BY: DEBRA D. CAMPBELL
Technical Data Plan
For Public Hearing:
2004-53

TD-1

SUBJECT: Administrative Approval for Petition No. 2004-53 by Citiline, LLC.

Rezoning Petition for:
Louisburg Square
Charlotte, NC

TD-1

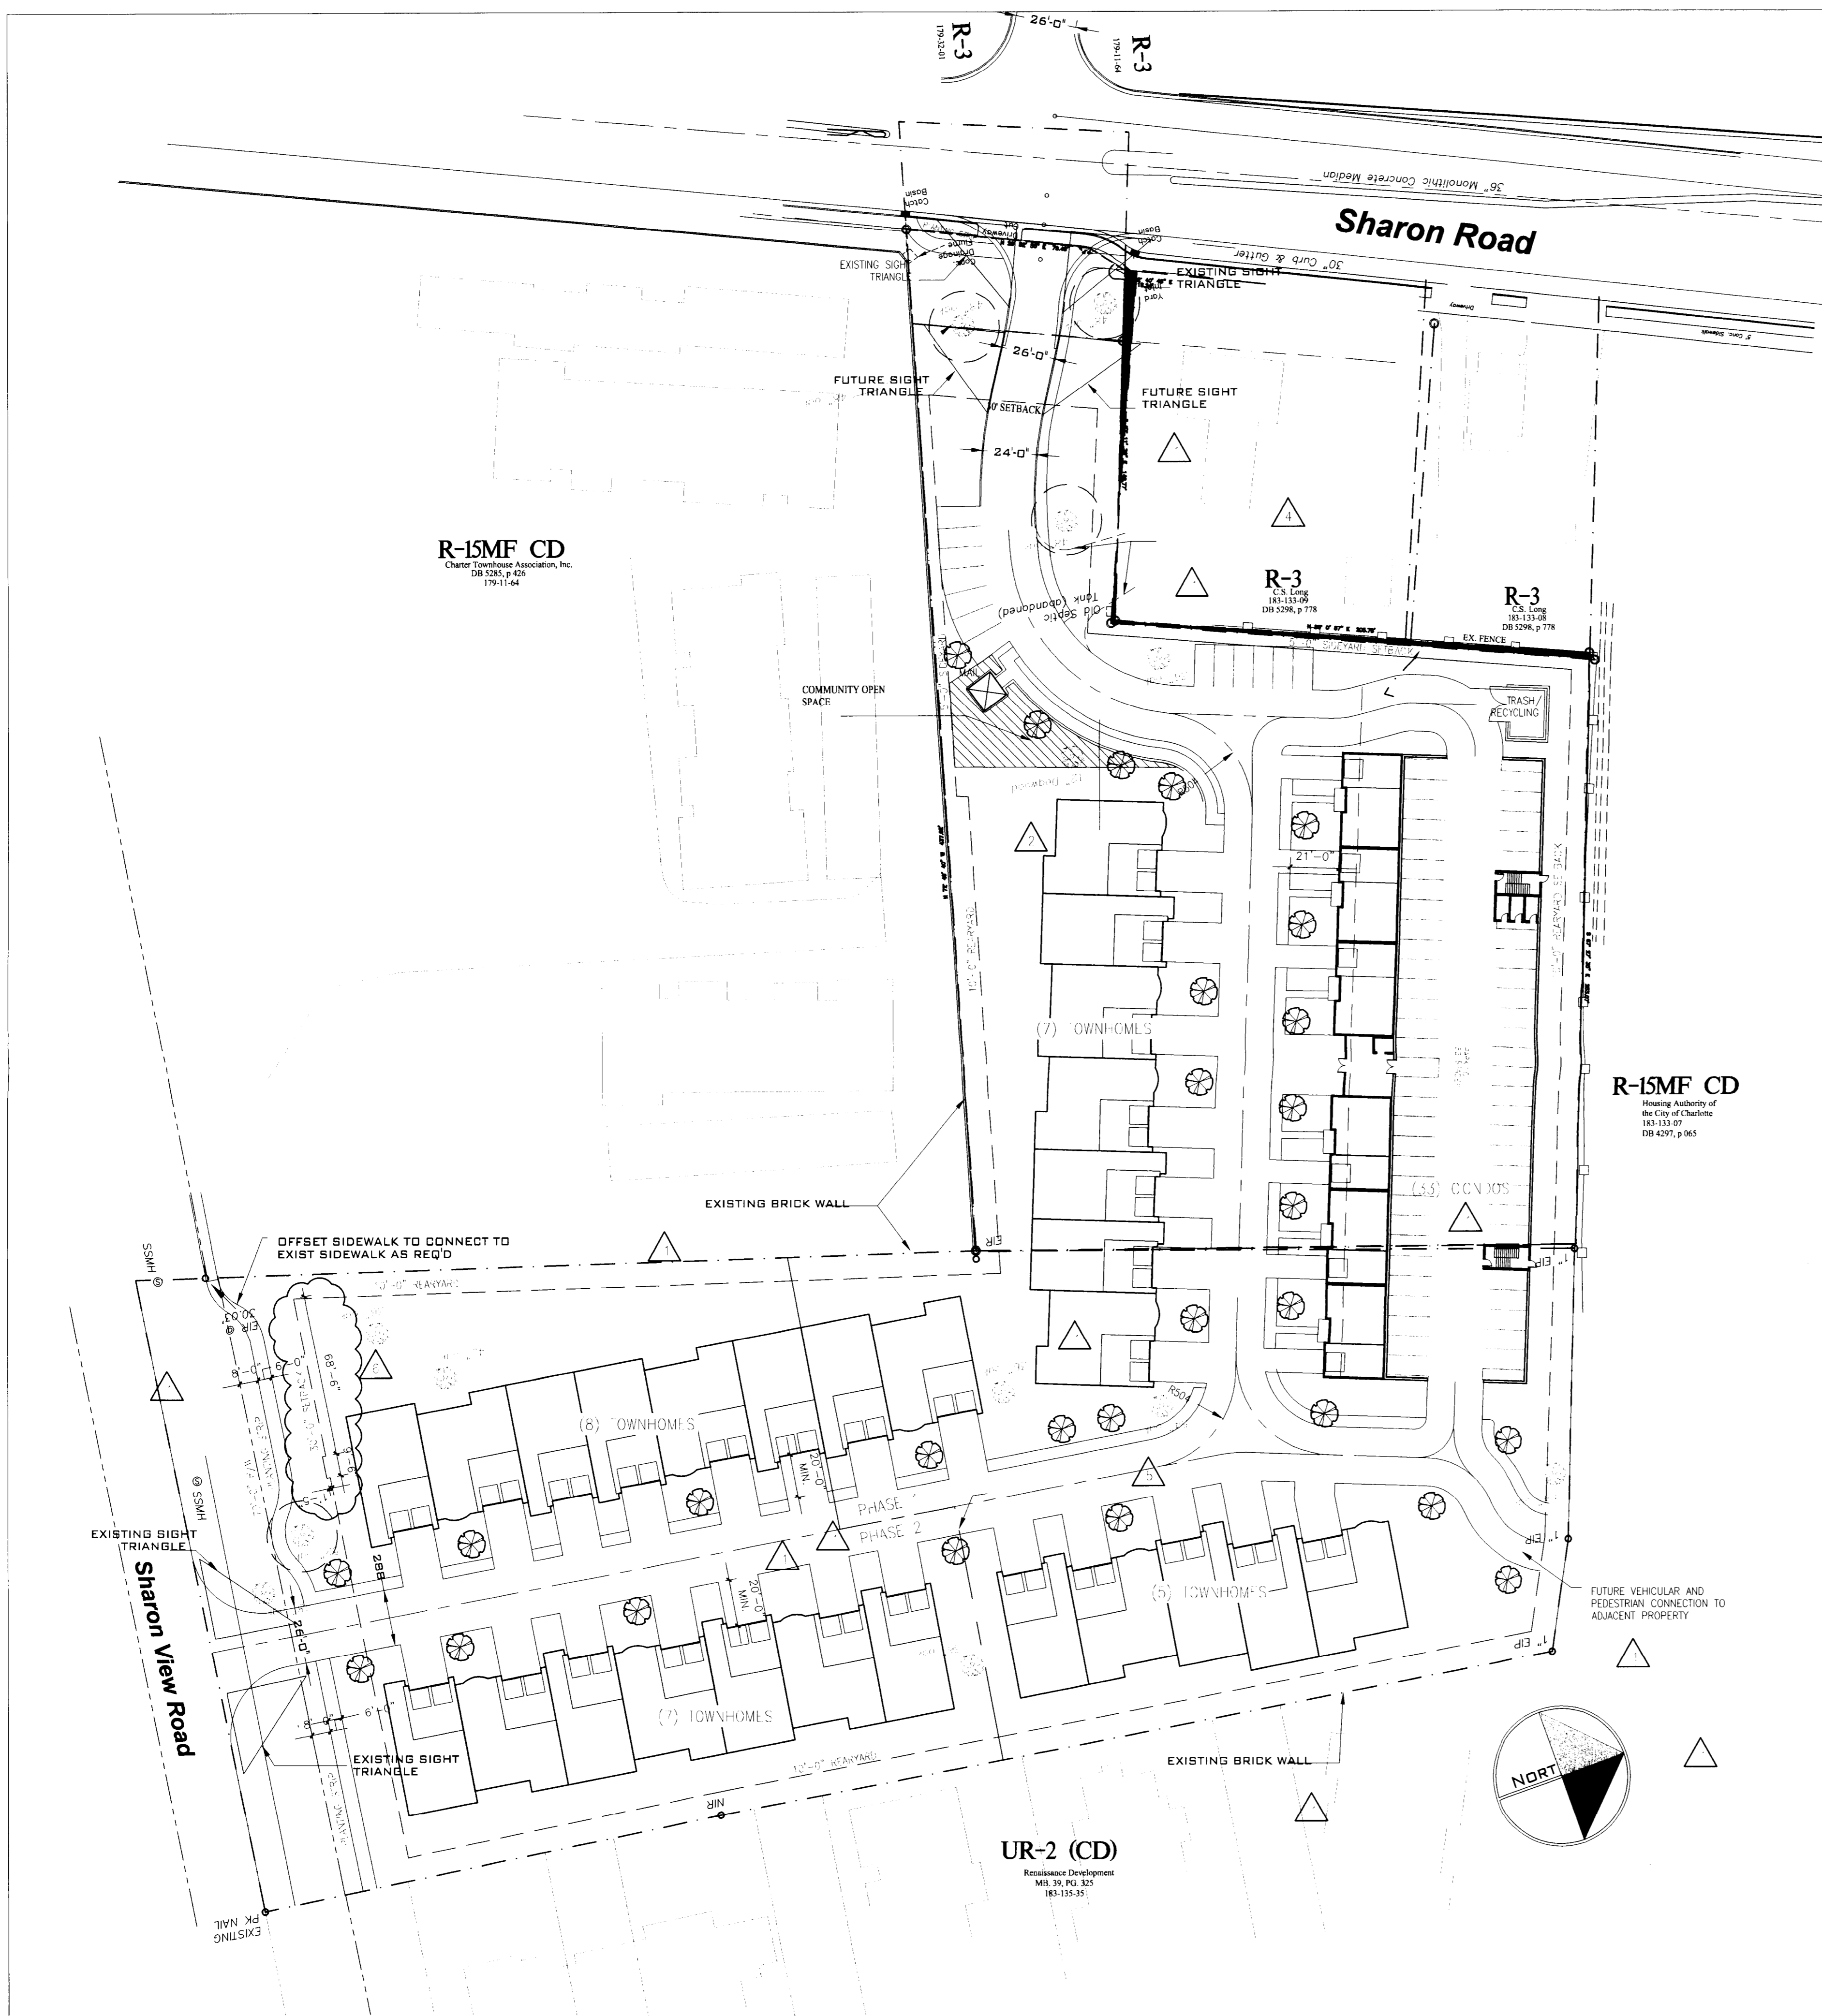
- The petitioner will dedicate and convey the appropriate right-of-way along Sharon View Road prior to the issuance of a building permit for Phase 2 (Sharon Road has already been dedicated by separate rezoning). A 6 foot sidewalk and 8 foot planting strip will be installed along the part of the property that abuts Sharon and Sharon View Roads. The sidewalk may meander and the planting strip may vary to save existing trees.

Attached is a copy of the revised plan (sheet TD-1) for the above rezoning petition. The plan has been revised to add a phasing note regarding the dedication of right-of-way along Sharon View Road. Since this change does not alter the intent of the development and is minor, I am administratively approving this revised plan. Please use this revised plan when evaluating requests for building permits and certificates of occupancy.
Note that the concepts renderings sheet attached to the original approval still applies.
